SUBJECT: Traffic Concern with LRT Station east of Moodie

Comment of LRT Stage2 Proposals at Moodie Drive

Subject: Stage2 LRT/LMSF Moodie & Corkstown

Moodie Station Design

Figure 1 – Updated Moodie LRT Station Design

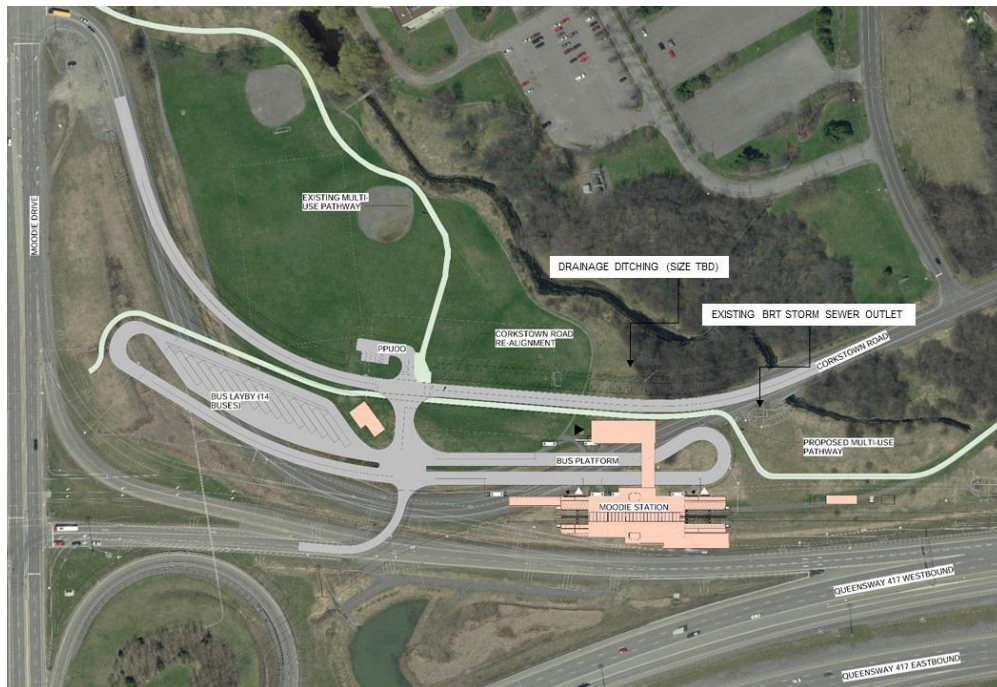
- As requested, additional details have been included in the sketch below: Drainage ditching as identified by the black lines directly beneath the orange line. Size and location will be confirmed during detailed design.

- The location of the existing storm sewer outlet for the BRT project.

- As indicated previously, the following principles are guiding the design of the station:
 - Minimize the footprint of the station;
 - Minimize the impact to Stillwater Creek; and,
 - Emphasize stormwater mitigation measures.
